Environmental Minor Project Refinement Form

Project Name: West of Devers Upgrade Project **Request Prepared By:** Sylvia Granados

Date Approval Required: 3/15/2021 **Variance Request No.:** 45

Southern California Edison
West of Devers Upgrade Project
Proposed Work Areas
MPR #45

FIGURE 1
Page 6 of 10

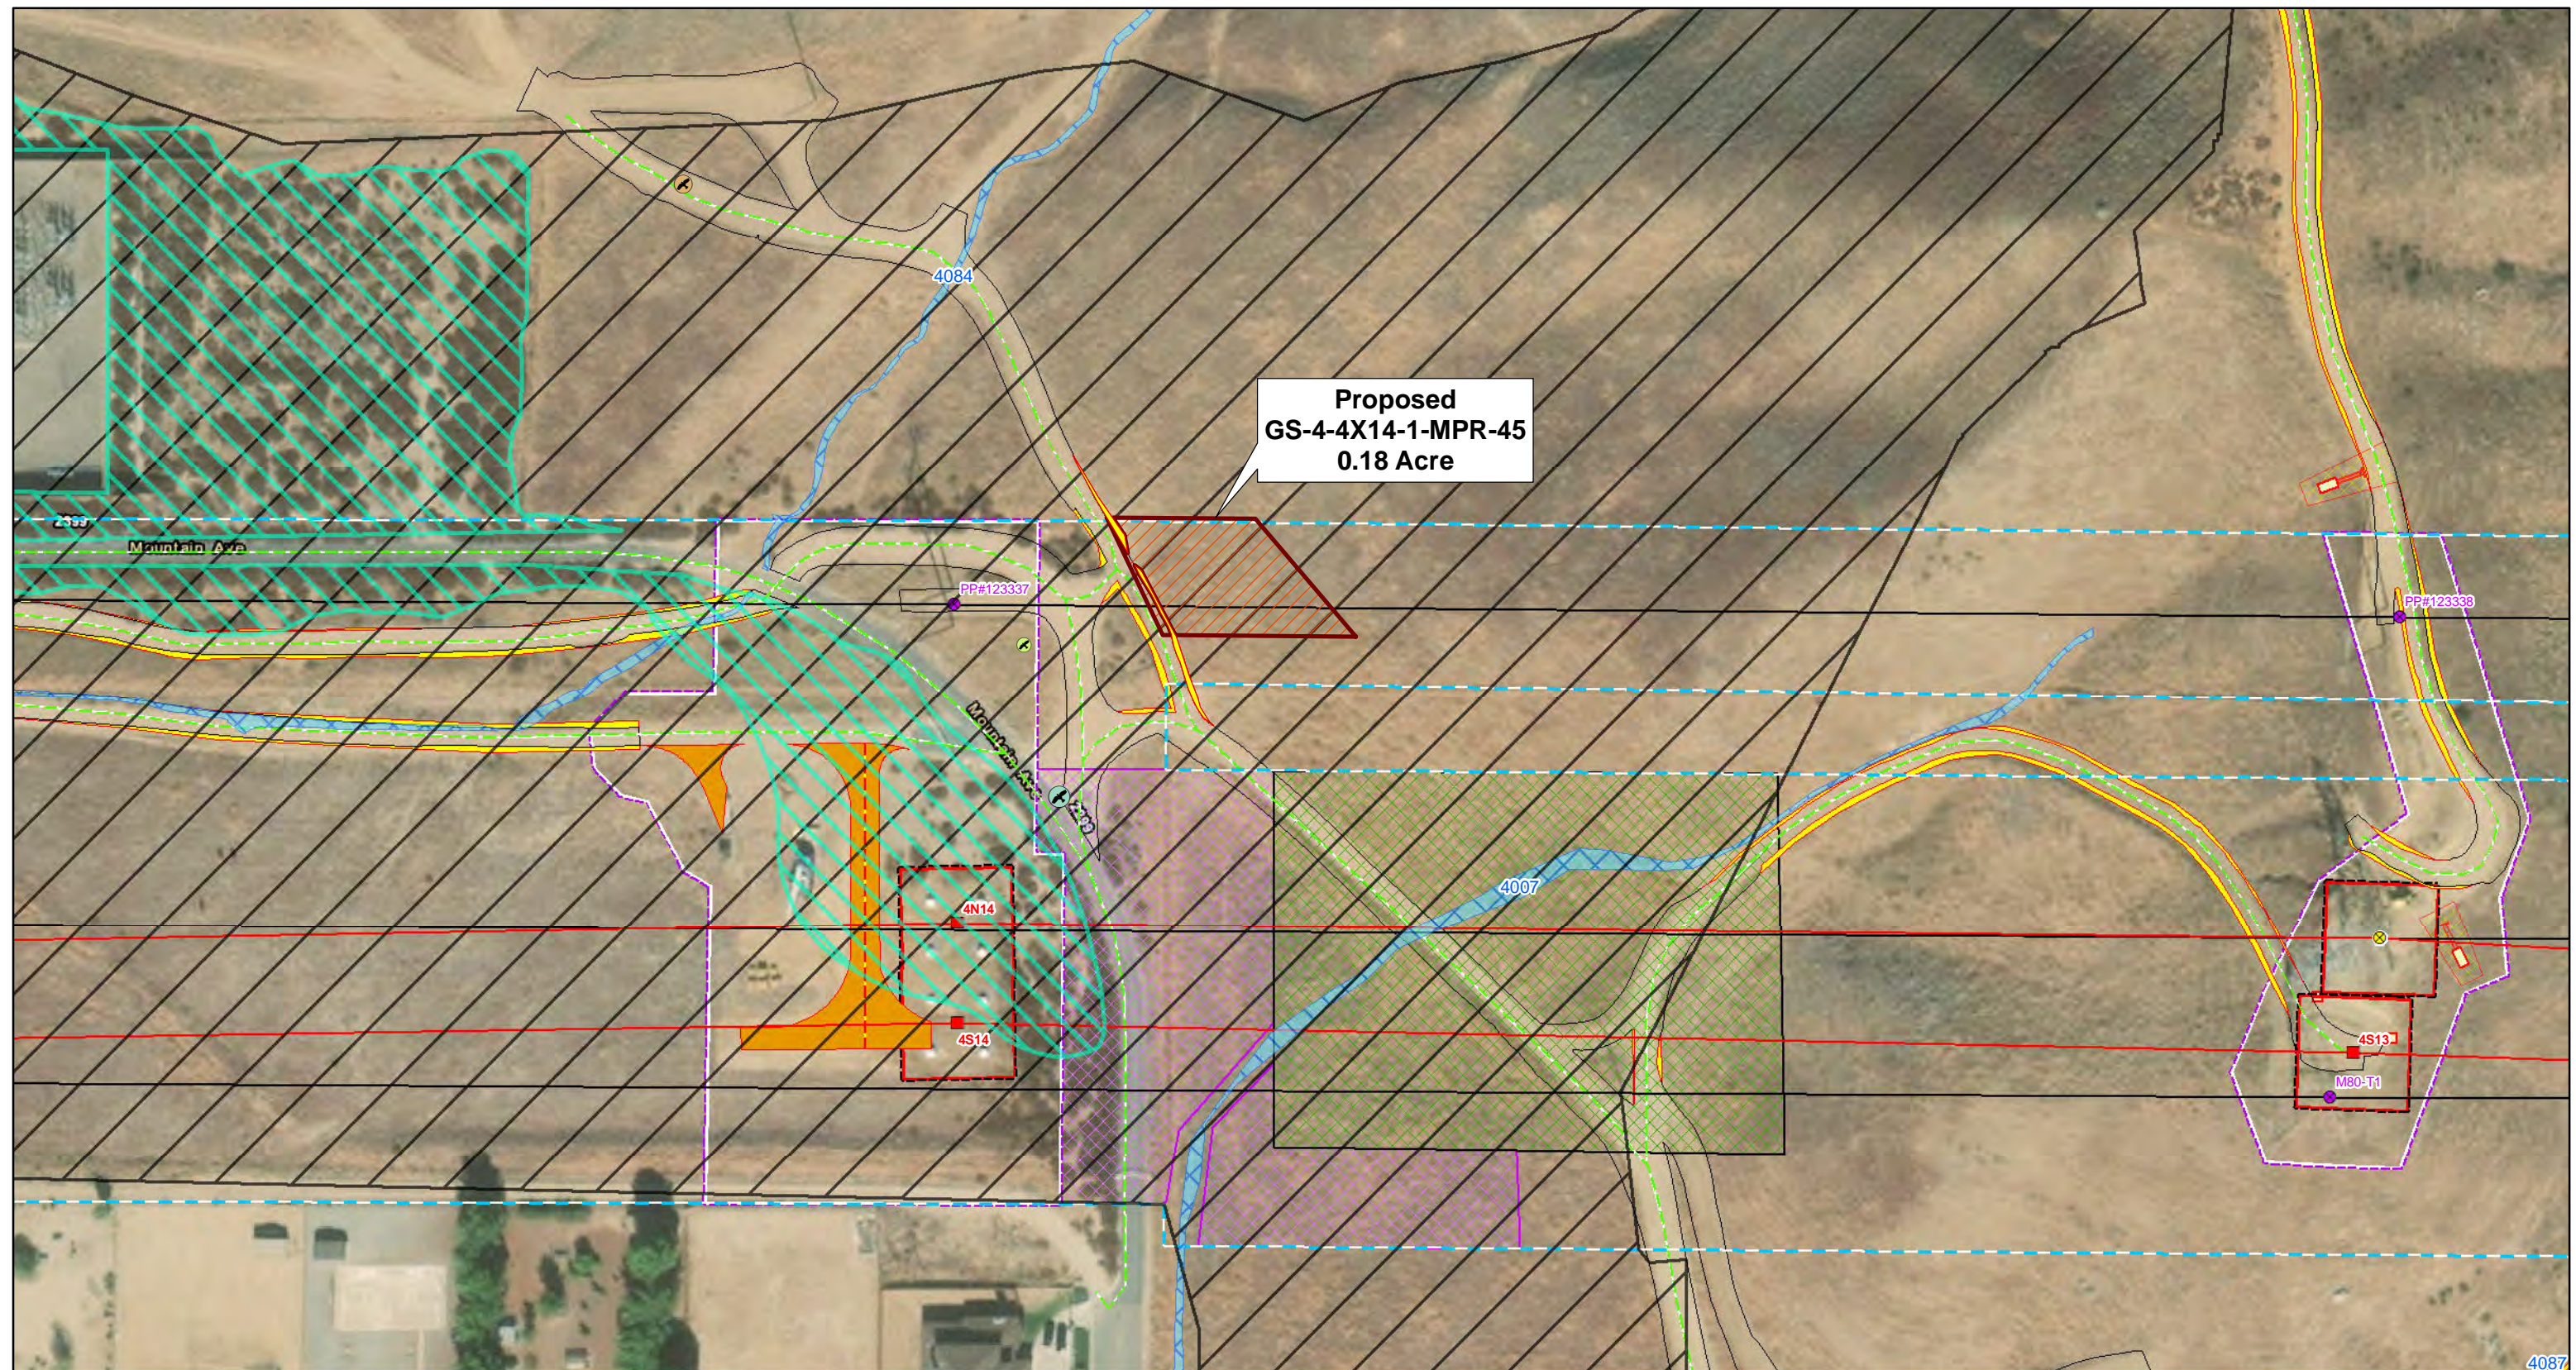
WSS-4-4X16-1-MPR-45 - Figure 1, page 6: Proposed Wire Site

A new 0.05-acre temporary work area north of 4N16 is required to expand approved WSS-4-4X15-4X16-MPR-34 to safely provide adequate work space for material and equipment staging during construction activities, as shown on Figure 1, Page 6.

FIGURE 1
 Page 8 of 10

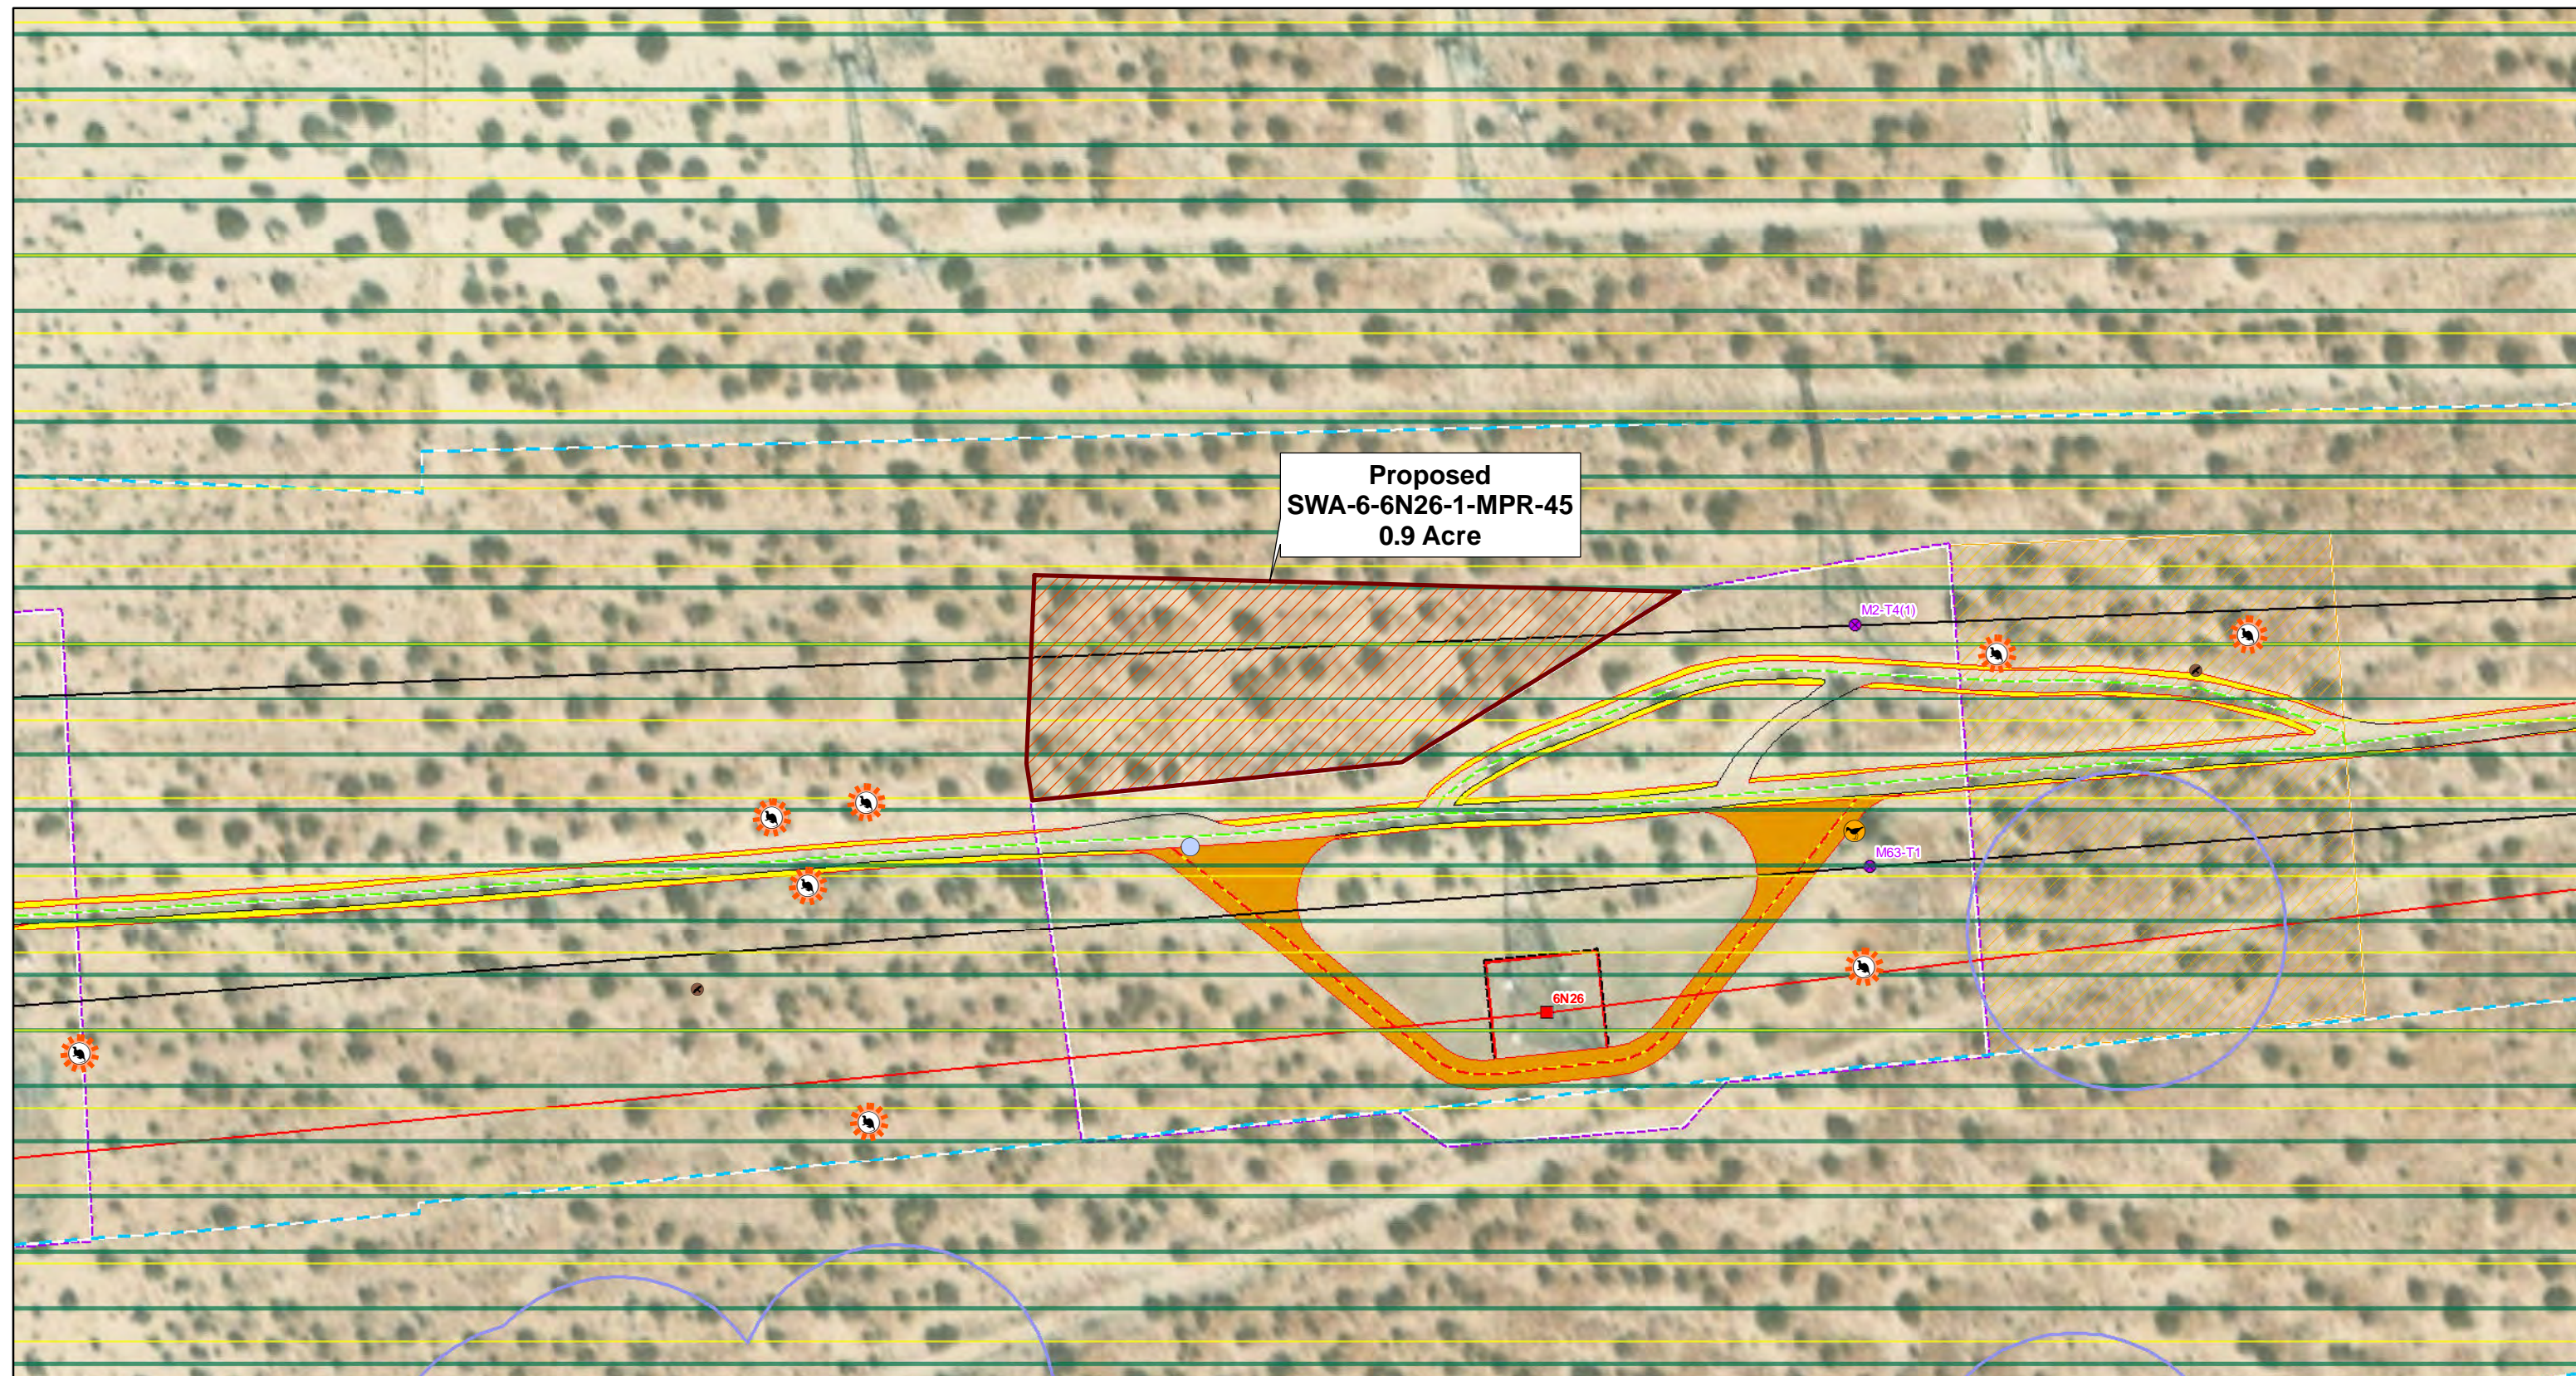
SWA-6-6N26-1-MPR-45 - Figure 1, page 8: Proposed Expansion of SWA-6-6N26 for Wire Wreck-out Activities

A new 0.9-acre temporary work area is required on the north side of SWA-6-6N26 to safely facilitate wire wreck-out activities associated with M2-T4(1) and M3-T1(1), as shown on Figure 1, Page 8. The new work area will be lightly graded to level the existing terrain.

Chaparral sand verbena (*Abronia villosa* var. *aurita*; CRPR 1B.1) occupied habitat has been observed approximately 300 feet southeast of SWA-6-6N26-1-MPR-45 across the associated access road, as shown on Figure 1, Page 8. The boundaries of the occupied habitat were staked with ESA signs along the access road. If additional special-status plants are later identified during clearance sweeps/monitoring, ESA buffers will be established and special-status plants will be avoided to the extent feasible. With implementation of these avoidance strategies and based on current levels of disturbance, the project is not expected to impact greater than 10 percent of the local occurrences. In addition to avoidance, drive and crush methods will be used to the extent possible for temporary work areas. If grading of temporary work areas is required, topsoil salvage will occur. Seed was also collected from these populations in 2019 and will be planted during the restoration phase of the project. Unavoidable impacts to special-status plants will be addressed in accordance with the Special-status Plant Salvage and Relocation Plan.

Coachella Valley milk-vetch (*Astragalus lentiginosus* var. *coachellae*; FE, CRPR 1B.2) modeled habitat overlaps SWA-6-6N26-1-MPR-45 and the associated access roads, as shown on Figure 1, page 8. However, no milk-vetch plants have been detected after many years of focused surveys. Therefore, no impacts are anticipated. If milk-vetch plants are discovered in the future, they will be addressed in accordance with the Biological Opinion and/or via the CV-MSHCP, in coordination with the CVCC and USFWS.

FIGURE 1
Page 9 of 10

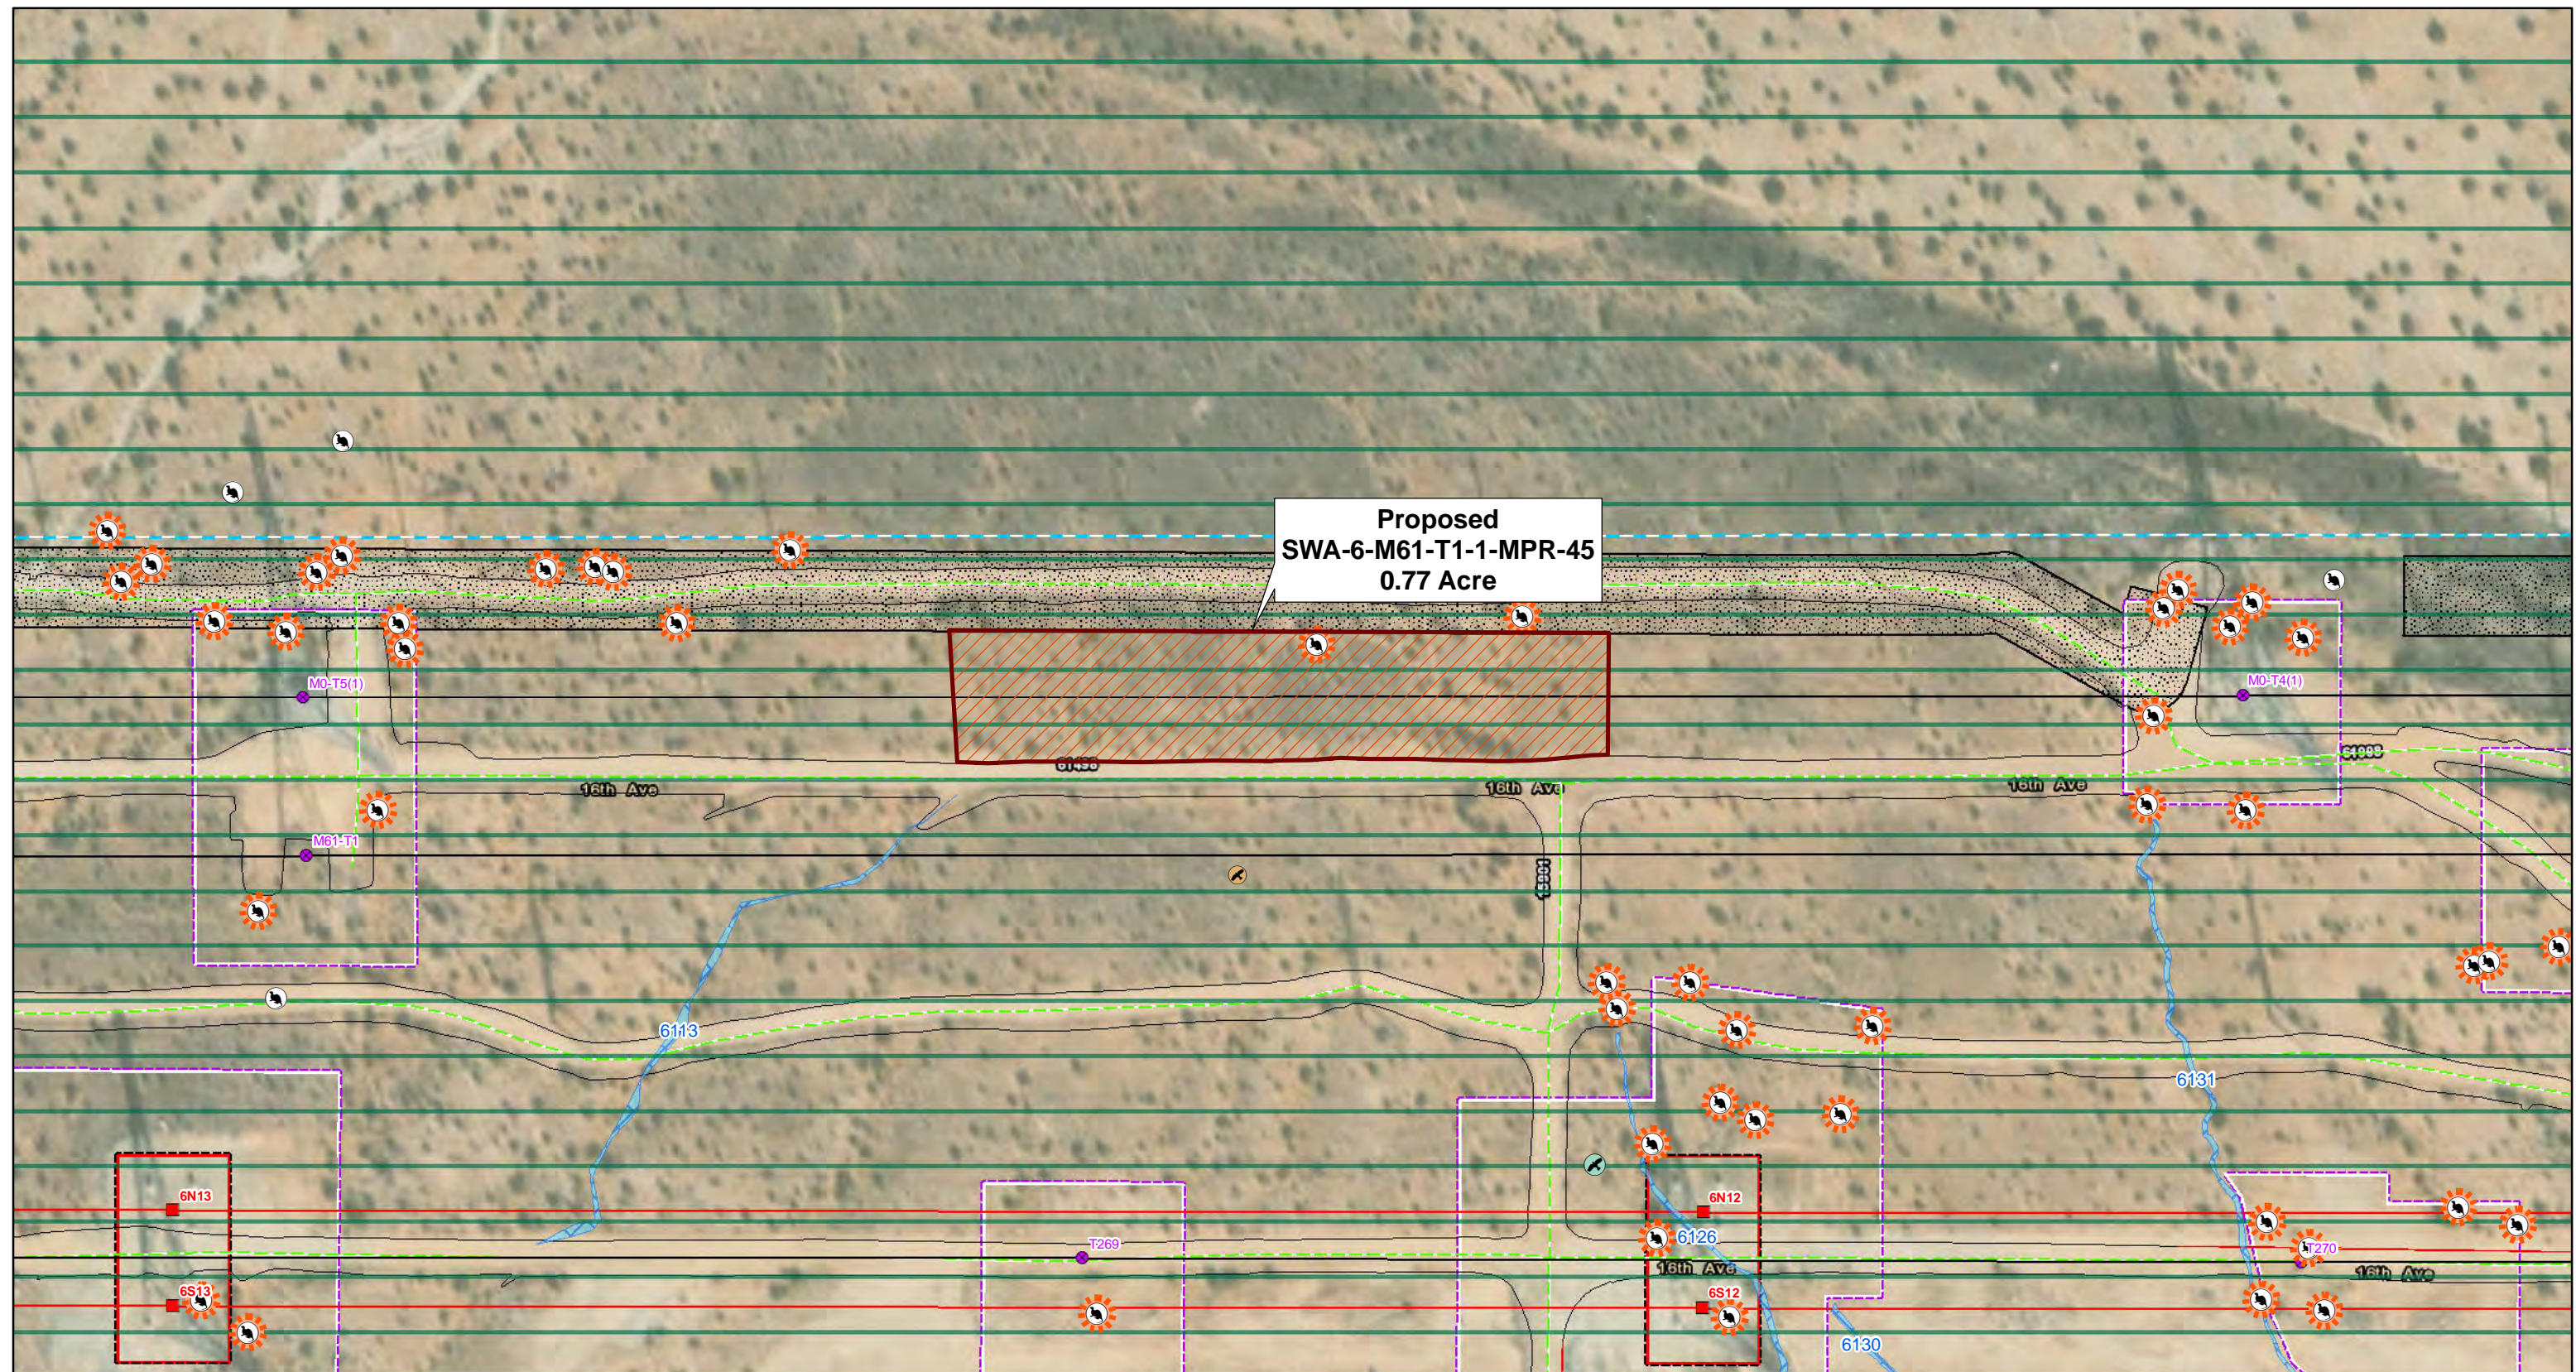
SWA-6-M61-T1-1-MPR-45 - Figure 1, page 9: Proposed Expansion of SWA-6-6N26 for Wire Wreck-out Activities

A new 0.77-acre temporary work area is required on the north side of 16th Avenue to safely facilitate wire wreck-out activities associated with M0-T5(1) and M0-T4(1), as shown on Figure 1, Page 9. The new work area will be lightly graded to level the existing terrain.

Desert woodrat midden was previously observed within SWA-6-M61-T1-1-MPR-45 (FRED Habitat Event 000660), as shown in Figure 1, Page 9. Desert woodrat middens have also been observed throughout the vicinity (FRED Habitat Events 000676-000678) as well as in the vicinity of SWA-6-6N26-1-MPR-45, as shown on Figure 1, page 8. A 10-foot no-entry buffer was established around each midden using ESA signs. If construction determines avoidance of a buffer is not possible, a qualified biologist will relocate the midden in accordance with the Special Status Small Mammal Avoidance and Minimization Plan.
